## COUNCIL ASSESSMENT REPORT

Panel Reference	PPSNTH-64
DA Number	10.2021.474.1 PAN 33806
LGA	Byron Shire
Proposed Development	Multi Dwelling Housing consisting of Fourteen (14) Townhouses, Six (6) Swimming Pools, Removal of Sixteen (16) Trees, Demolition of Existing Dwelling, Associated Earthworks, Upgrade to Drainage Channels and Compensatory Planting
Street Address	103 Paterson Street, Byron Bay NSW 2481
Applicant/Owner	Planit Consulting
Date of DA lodgement	24 September 2020
Total number of Submissions	• [69]
Number of Unique Objections	• [41]
Recommendation	Refusal
Regional Development Criteria (Schedule 7 of the SEPP (State and Regional Development) 2011	<b><i>Schedule 7 Regionally significant development 3(b)</i></b> <b><i>3 Council related development over \$5 million</i></b> <b><i>(b) the council is the owner of any land on which the development is to be carried out...</i></b>
List of all relevant s4.15(1)(a) matters	<ul style="list-style-type: none"> <li>Byron LEP 2014; SEPP 55 Remediation of Land; SEPP (BASIX) 2004; SEPP (Infrastructure) 2009; SEPP (State and Regional Development) 2011</li> <li>Byron Development Control Plan 2014</li> <li>Environmental Planning and Asses

## Tree removal and native vegetation clearing Plan:

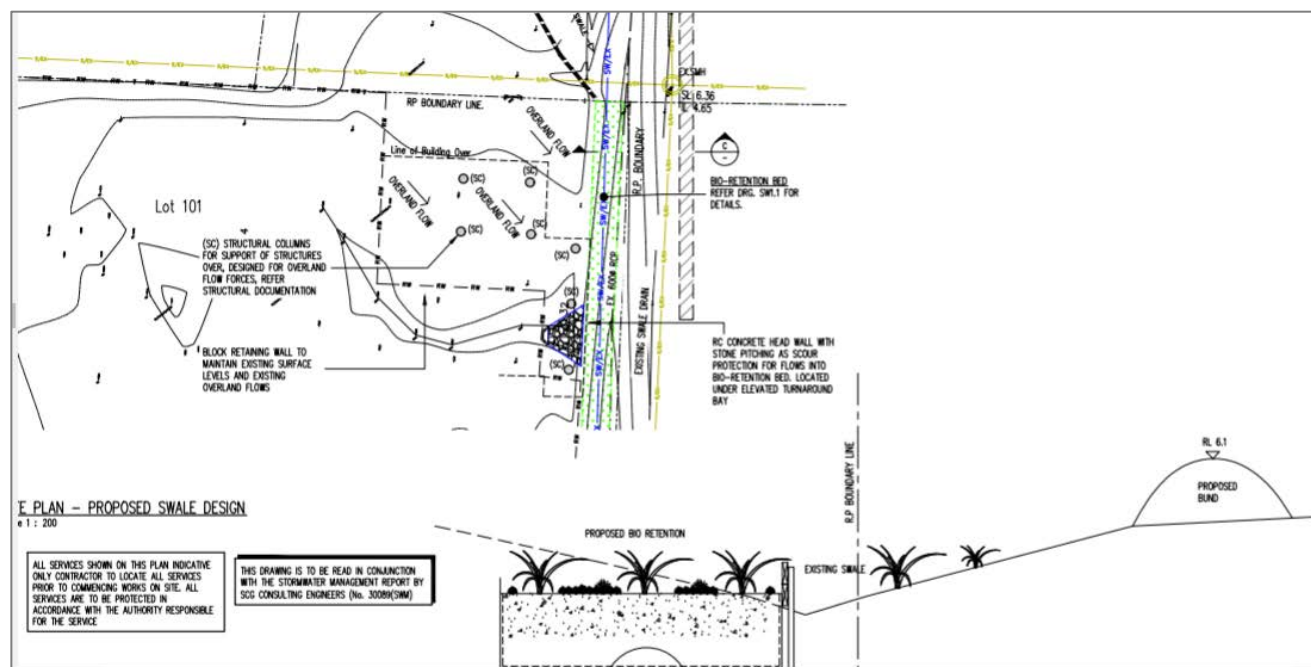
Although the proposed vegetation removal as described in the application has been reduced, the total amount of clearing relative to the existing vegetation on the site remains substantial. Of note is the proposed removal of approximately 750 m<sup>2</sup> of *Swamp Sclerophyll Forest on Coastal Floodplains of the NSW North Coast, Sydney Basin and South East Corner Bioregions* which is an Endangered Ecological Community listed under Schedule 2 of the BC Act. Furthermore, trees proposed to be retained are in very close proximity to the proposed development footprint.

Even if these trees can be retained during construction of the development (as concluded in the submitted arboricultural report) they are unlikely to be retained in the long-term. Trees located in such close proximity to residential development invariably lead to conflicts, and these conflicts are almost never resolved in the tree's favour. Therefore, it is considered that the full impacts to native vegetation have been underestimated.

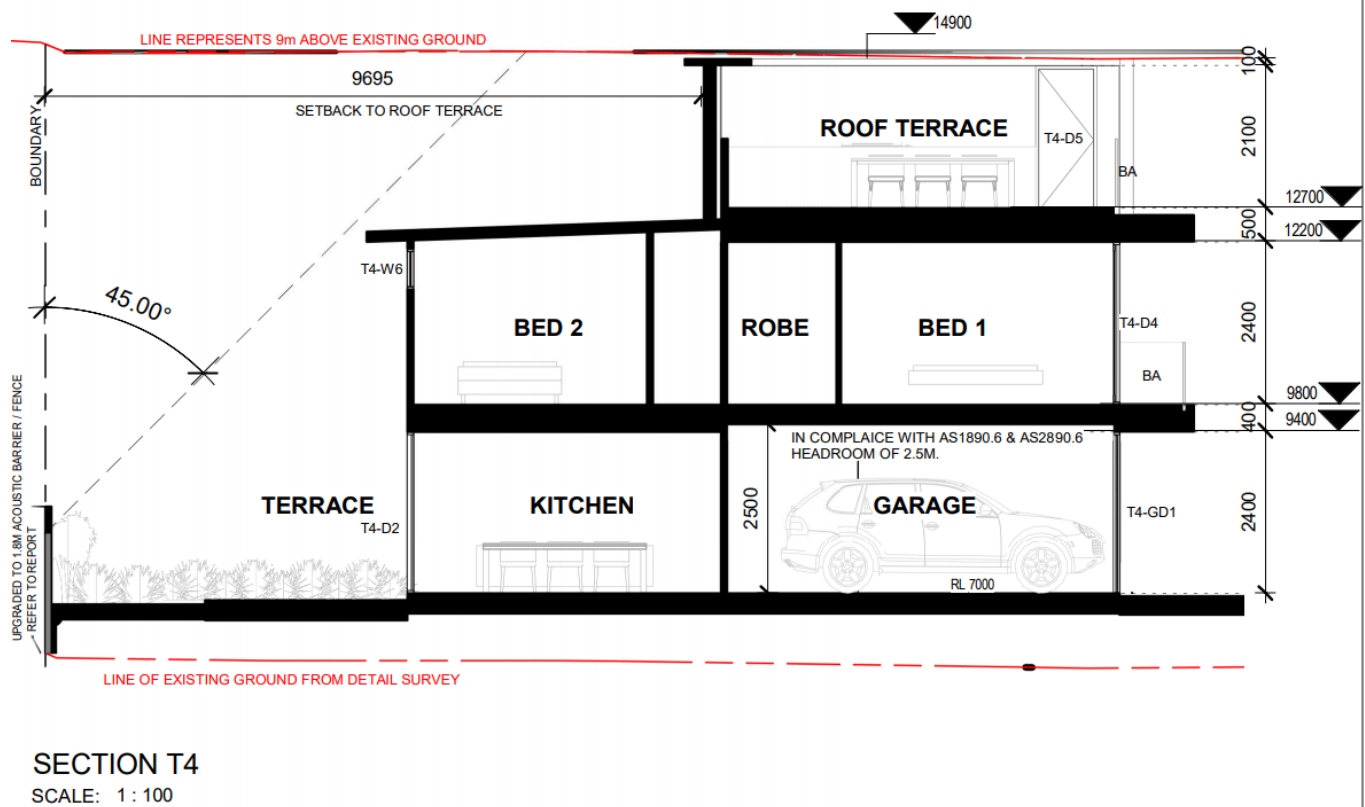
Parts of the roof exceed the 9 metre building height limit.

The proposal does not meet the objectives and development standards of this clause:

9am Midwinter

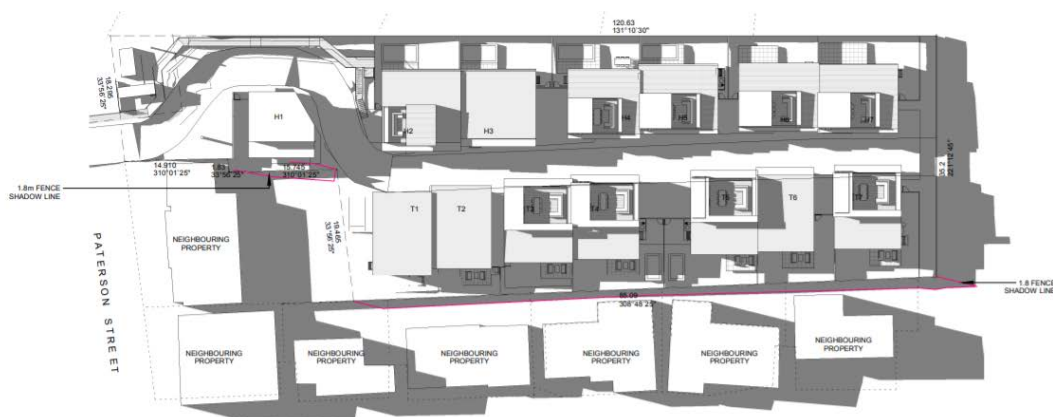
Shadow diagrams provided with the application indicate that the development will significantly overshadow the neighbouring property to the south during the morning hours in midwinter:
